January 2, 2003

**Re: GE-Pittsfield/Housatonic River Site  
Former Oxbow Areas J and K (GECD420)  
Addendum to Pre-Design Investigation Work Plan**

ADDENDUM TO PRE-DESIGN INVESTIGATION WORK PLAN FOR  
FORMER OXBOW AREAS J AND K REMOVAL ACTIONEXISTING SOIL PCB DATA AND PROPOSED USAGE

GENERAL ELECTRIC COMPANY  
PITTSFIELD, MASSACHUSETTS  
FORMER OXBOW AREAS J AND K  
**EXISTING AND PROPOSED APPENDIX  
IX + 3 SOIL SAMPLE LOCATIONS  
(0- TO 1- FOOT INTERVAL)**

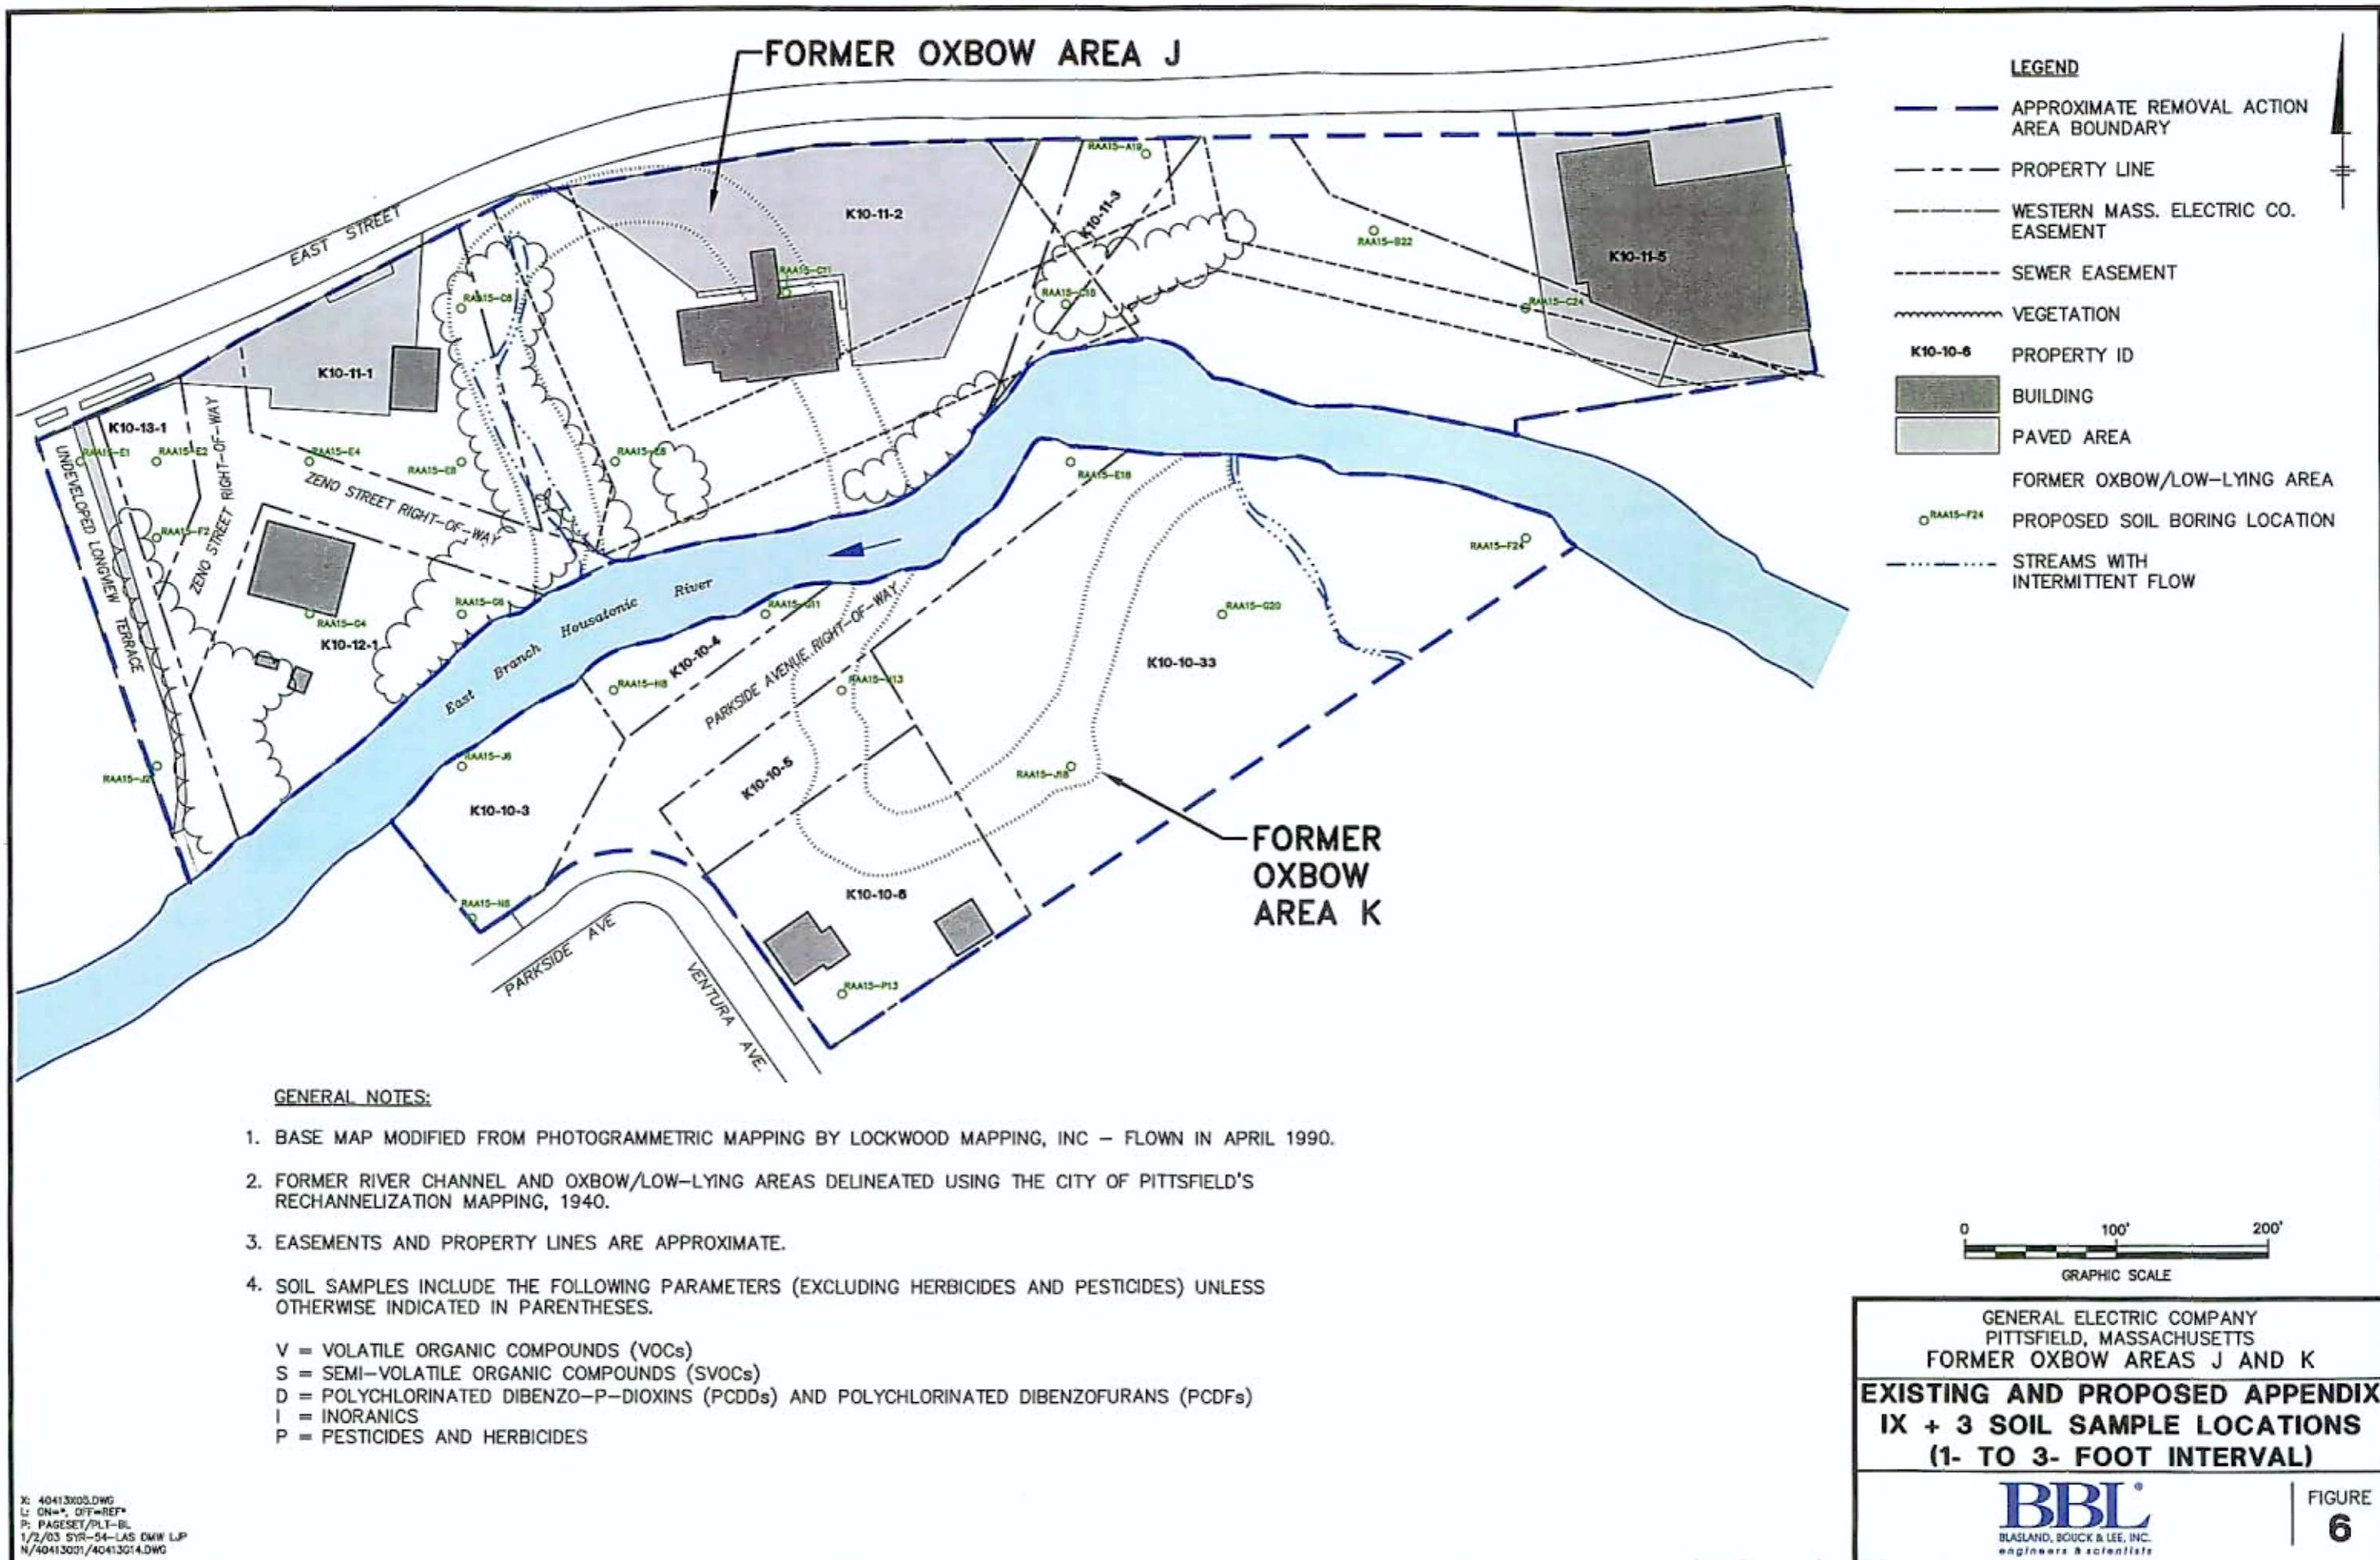
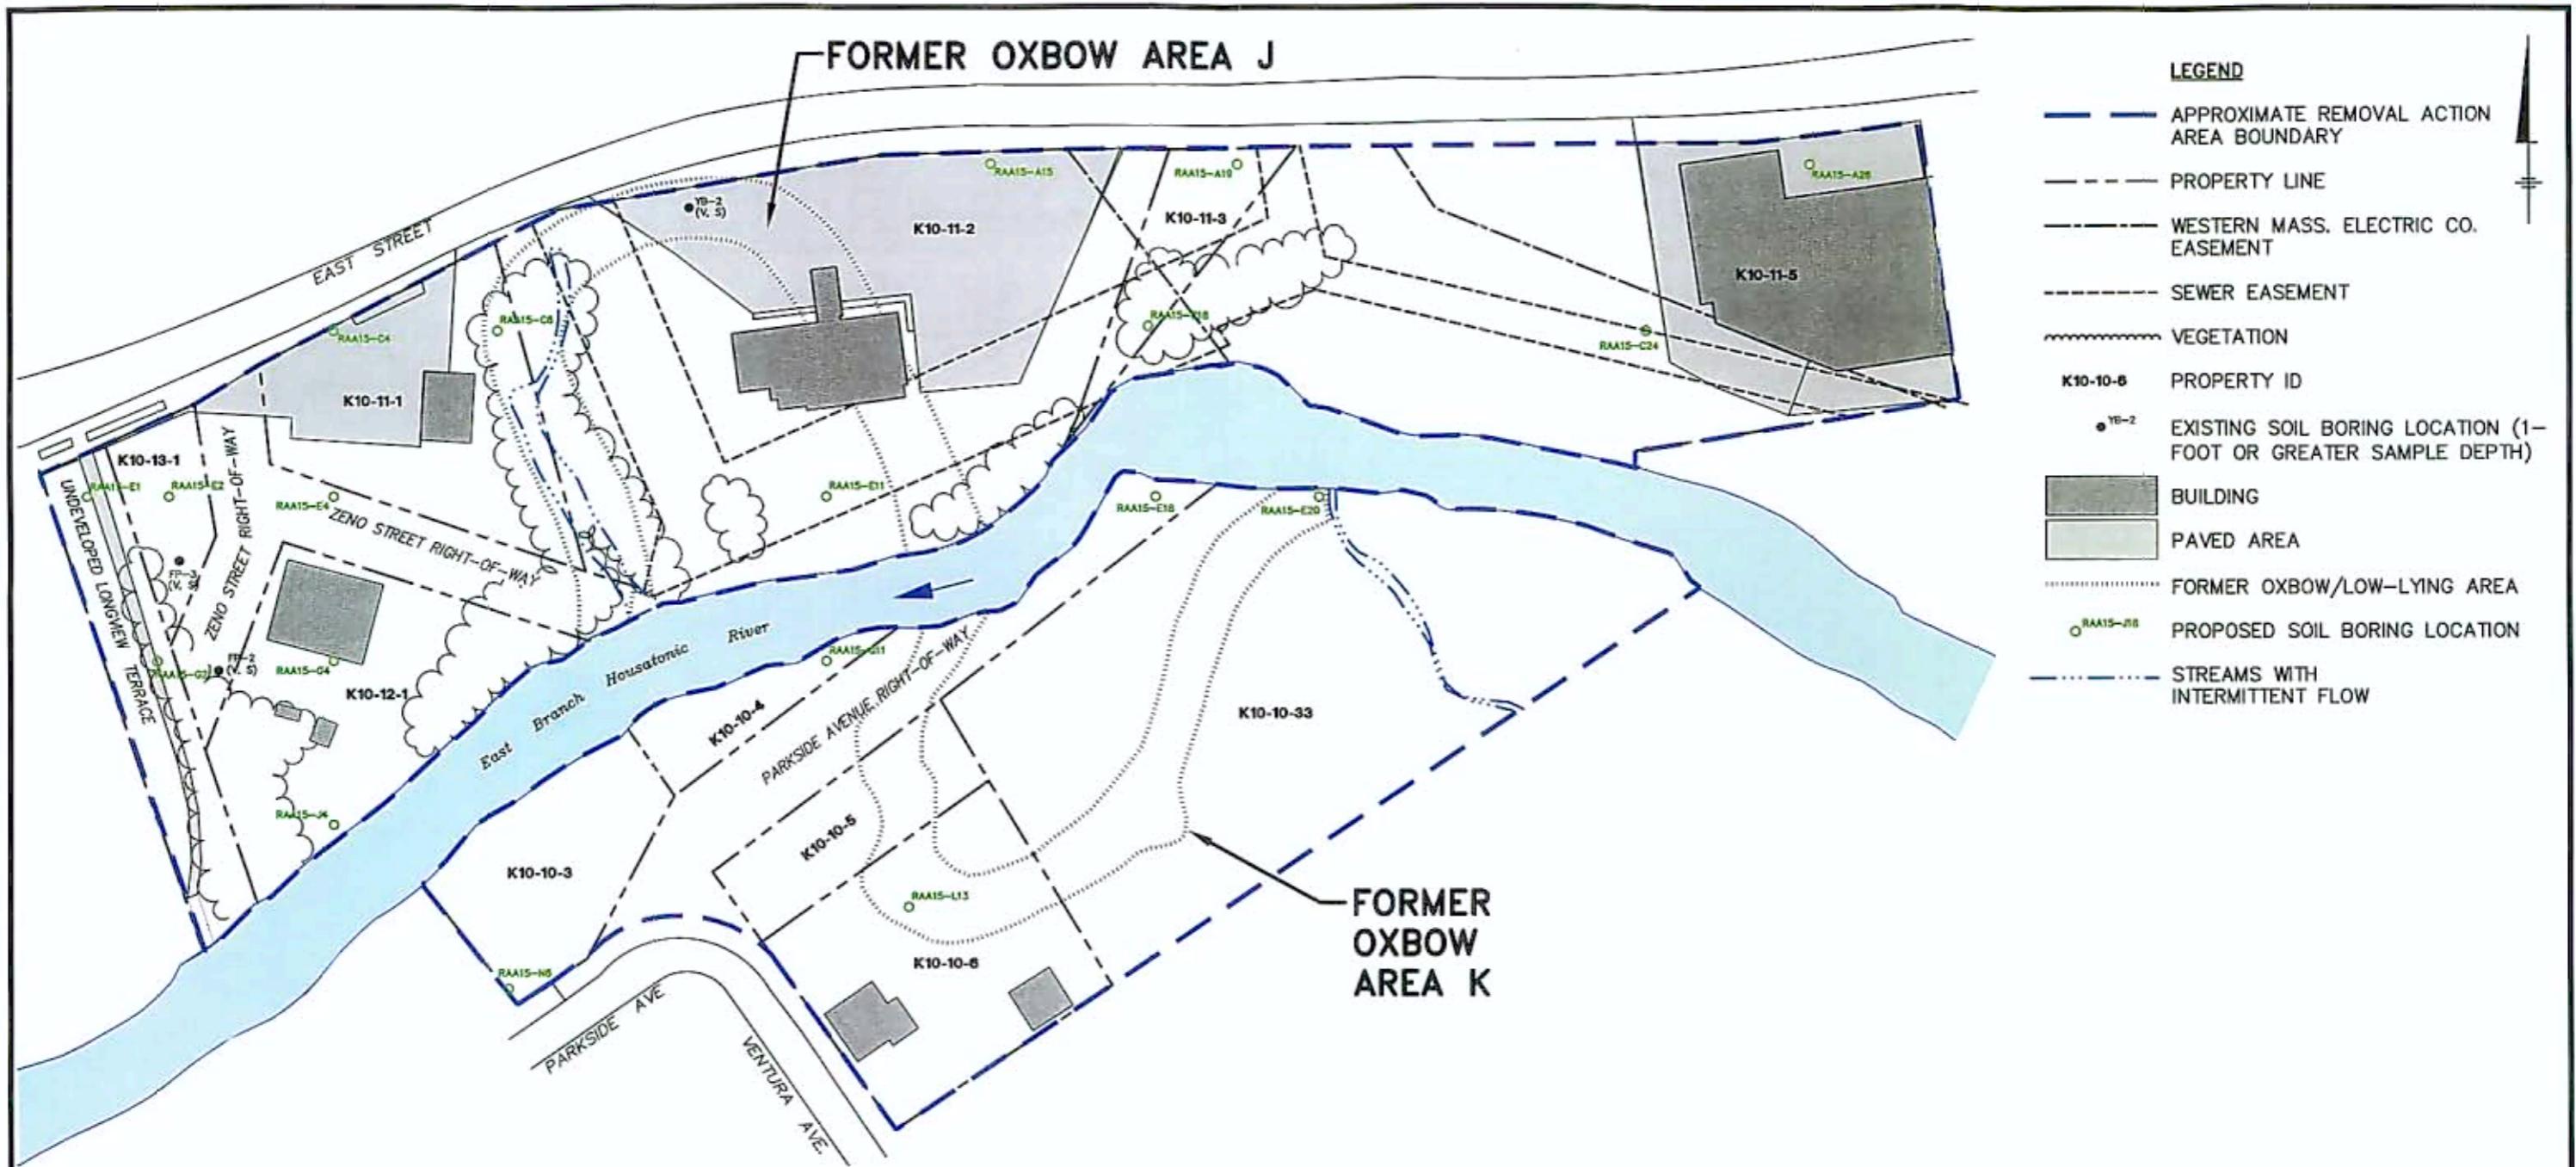
3. Condition No. 3 of EPA's conditional approval letter directs GE to modify the proposed Appendix IX+3 soil investigations at the non-residential portions of this RAA by adding or re-locating a number of the proposed Appendix IX+3 samples. GE has adopted the additions and modifications described in this EPA comment, and the attached revised tables and figures reflect those changes, with the following exception:

After further review, there is confusion regarding the 3<sup>rd</sup> and 9<sup>th</sup> bullets of EPA's Condition No. 3. EPA requires that additional soil samples be collected at location RAA15-J9 for Appendix IX+3 characterization at Parcel K10-10-4 – one at the 1- to 3-foot depth and one at the 3- to 6-foot depth. However, the RAA15-J9 location is not situated within Parcel K10-10-4. Rather, it is situated within residential Parcel K10-10-5, as expanded per Condition No. 2.iii of EPA's conditional approval letter. Moreover, the Appendix IX+3 sampling that is already proposed is sufficient to characterize these soils. Specifically, for Parcel K10-10-4 (which is very small), three Appendix IX+3 samples are already proposed for the overall 1- to 6-foot depth (two for the 1- to 3-foot depth and one for the 3- to 6-foot depth), as shown on Figure 6 and 7. For residential parcel K10-10-5, the Appendix IX+3 sampling requirements are met by the proposed sampling described under Condition No. 5 below. In these circumstances, GE does not believe that the additional samples at location RAA15-J9 are needed, and hence it proposes not to collect those samples.

In addition, GE has further reviewed the available/proposed Appendix IX+3 sampling for the undeveloped portion of Longview Terrace that will be evaluated as a separate averaging area (consistent with Condition No. 2.i of EPA's conditional approval letter). Based on this review, GE proposes to collect an additional Appendix IX+3 sample at location RAA15-E1 at the 1- to 3-foot depth, so as to obtain a better subsurface distribution of Appendix IX+3 soil samples within this averaging area.
